RE: APD SE Area Command Center Project – Narrative

DRB Project Number: 1003450 Hearing Date: Feb 3, 2016  
 Project: 800 Louisiana Agenda Item No: (1)

SUBJECT: Site Plan for Building Permit

**Subject:** Project # 1003450, Case # 15EPC-40029 – APD SE Area Command

City Project No. **6213** Zone Map No. **L-19-Z** Sheet **SHEET #4** Of **4**

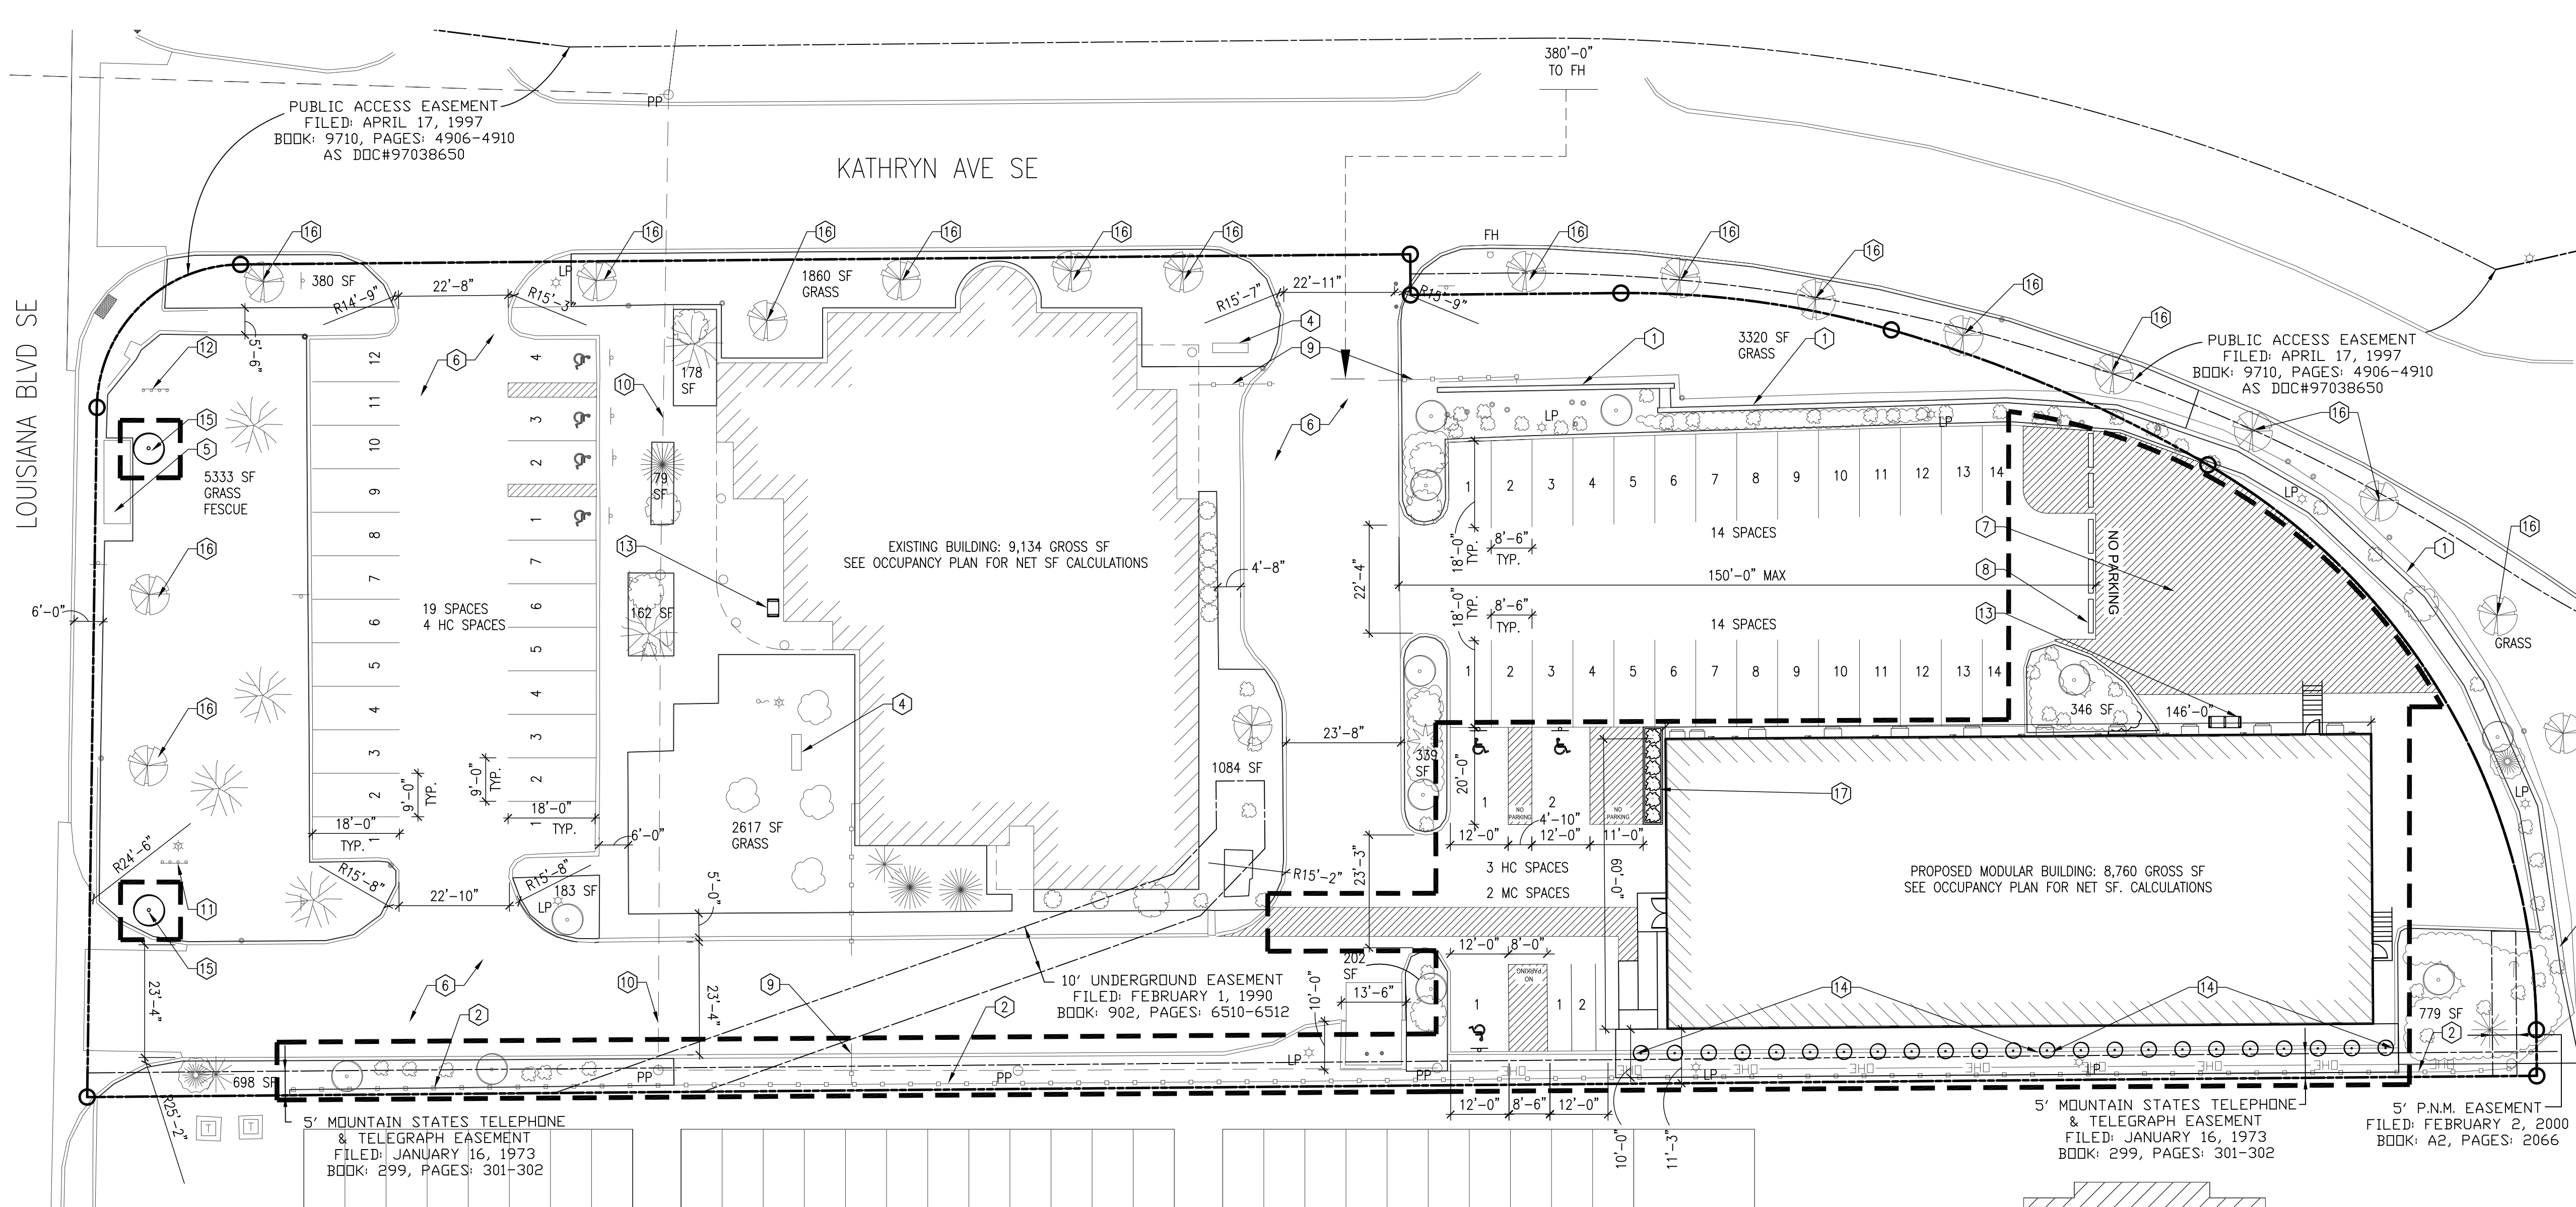
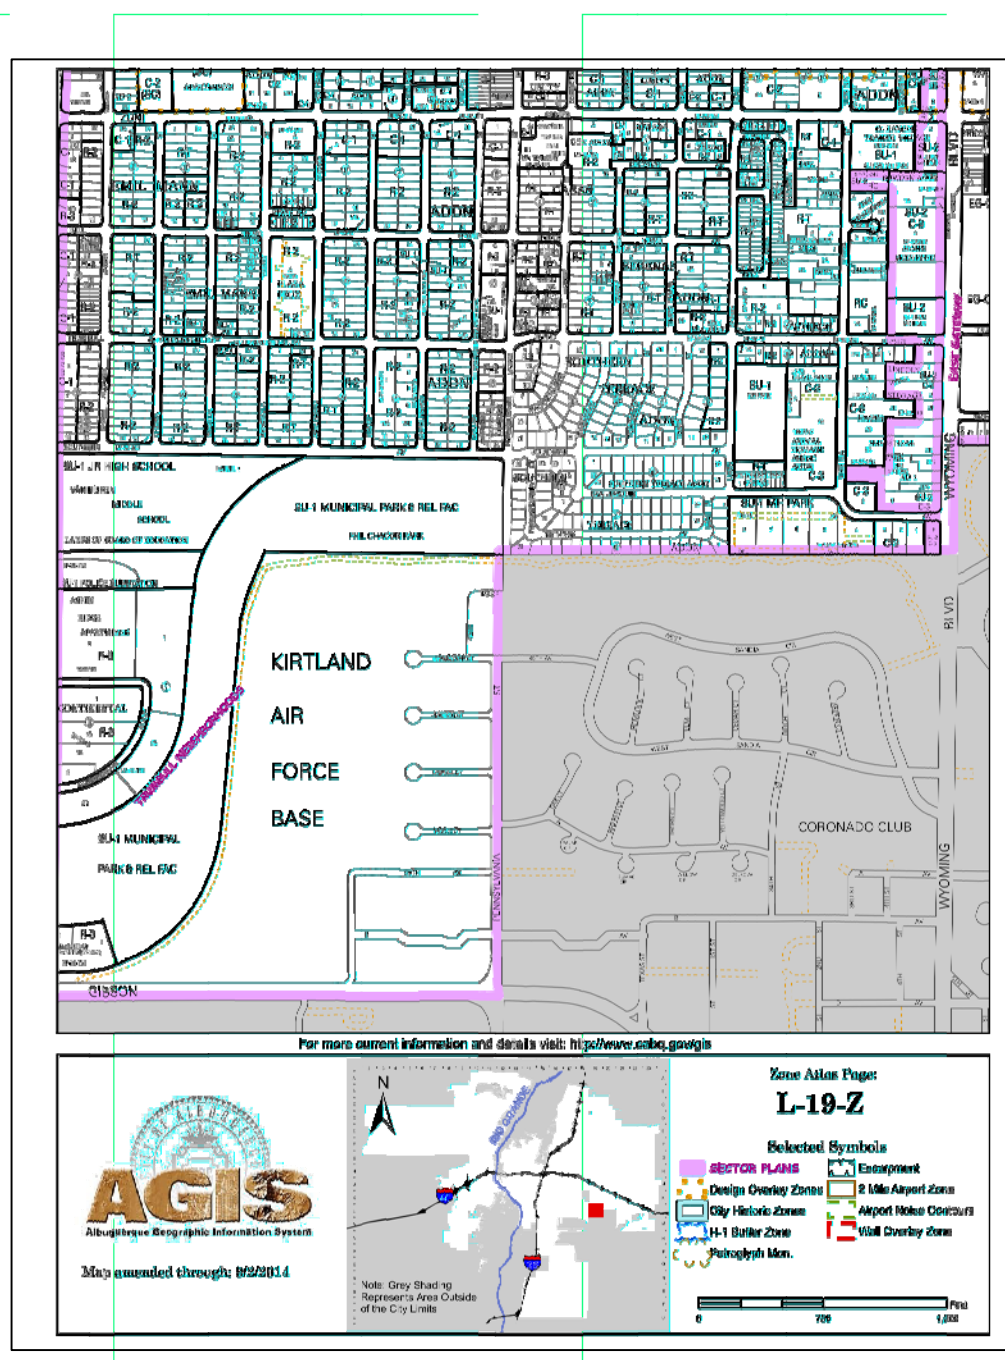
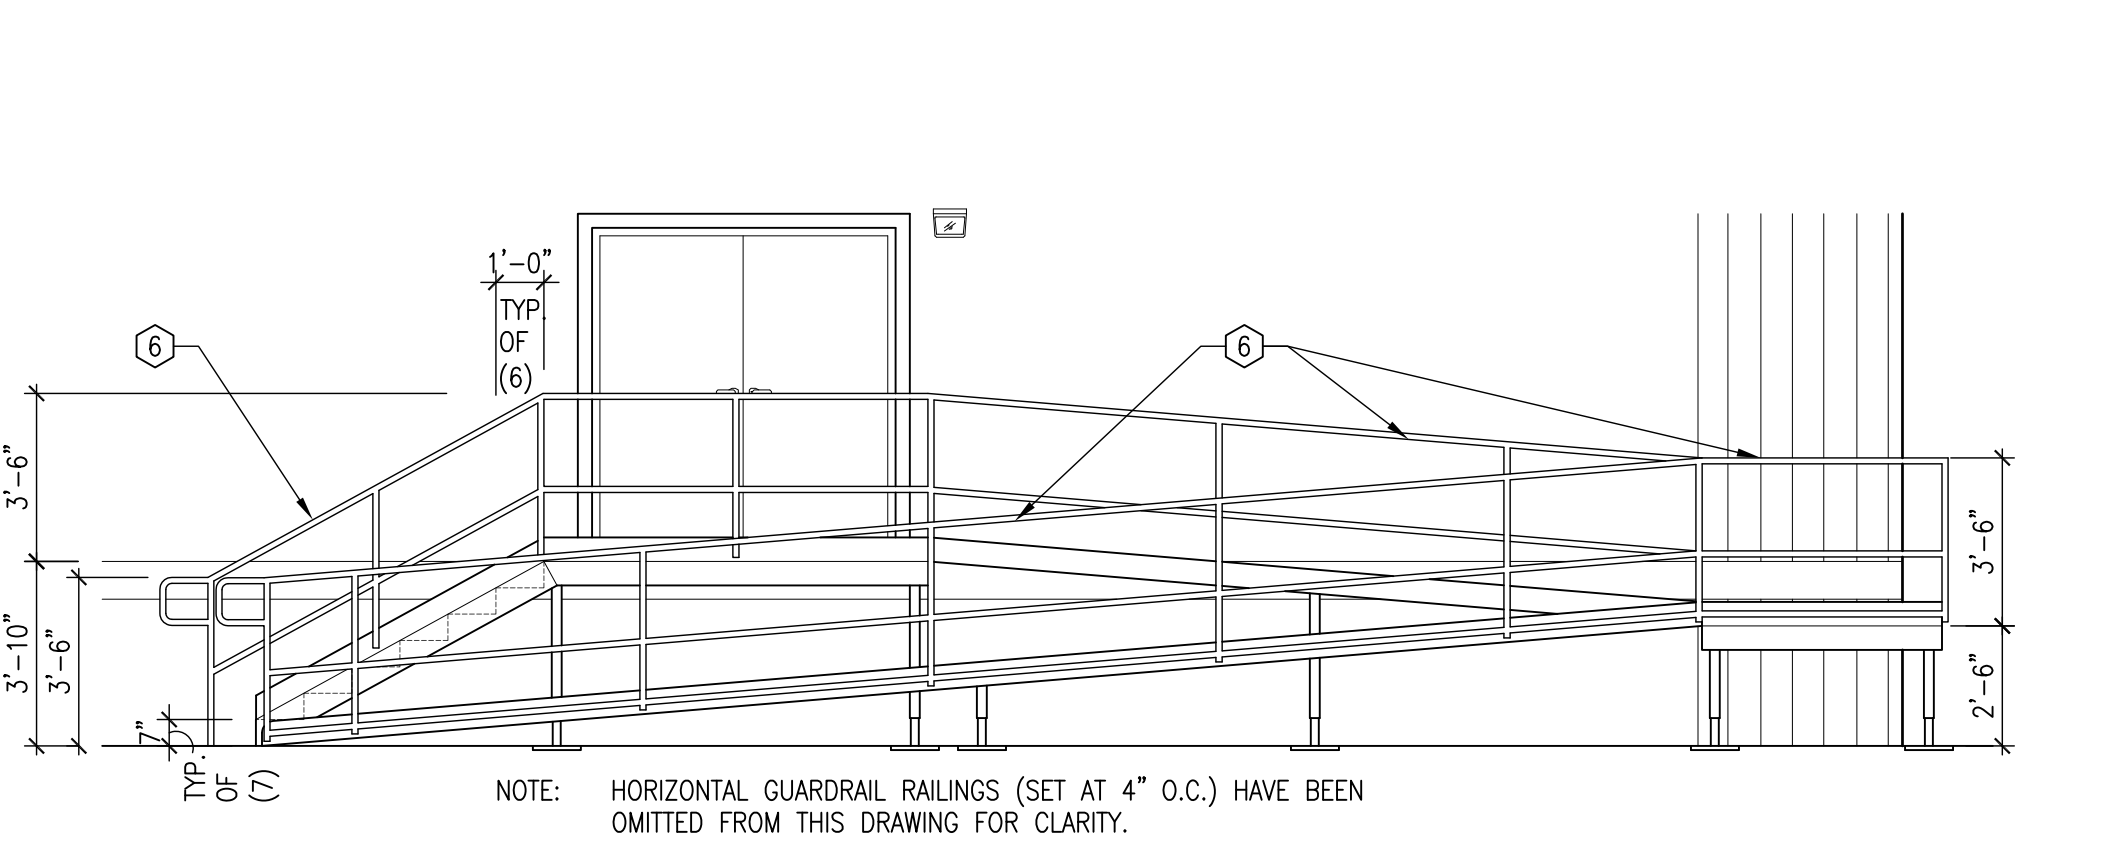
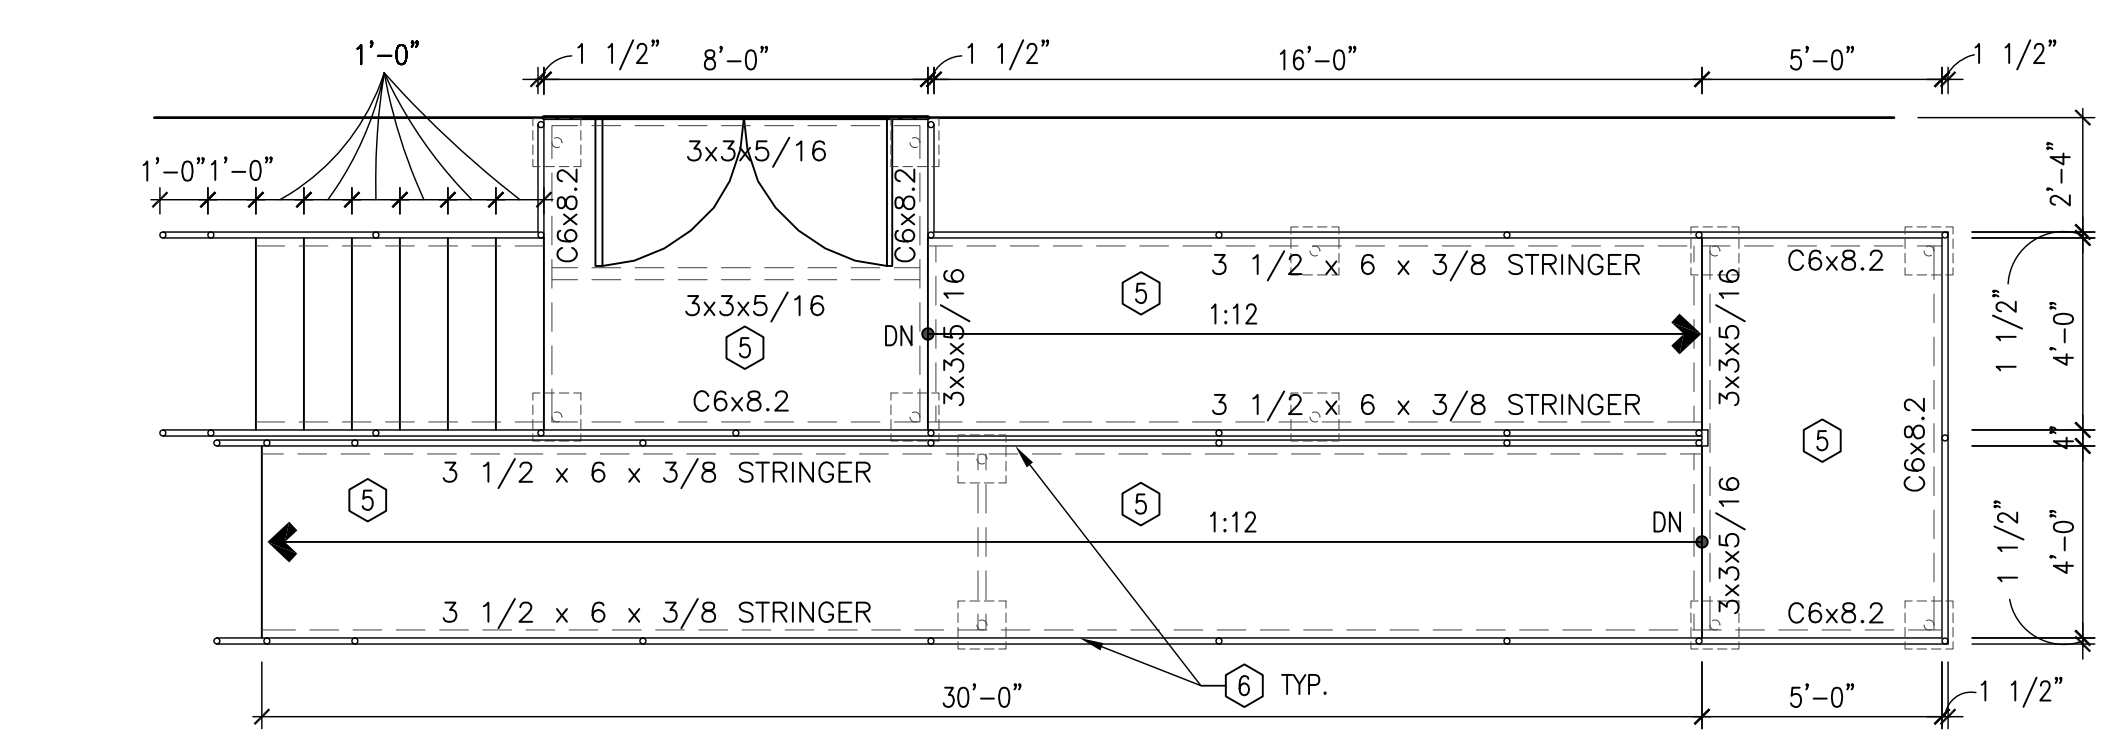
2. The ADA accessible parking sign must have the required language per 66-7-352.4C NMSA 1978 **"Violators Are Subject to a Fine and/or Towing."** Please show detail of ADA signs. **The required language is met and the details are shown on Sheet #4.**

4. Please detail ADA ramps from public right-of-way and proposed ADA ramps into modular building. **ADA ramps are called out on Sheet #1 and details are shown on Sheet #4.**
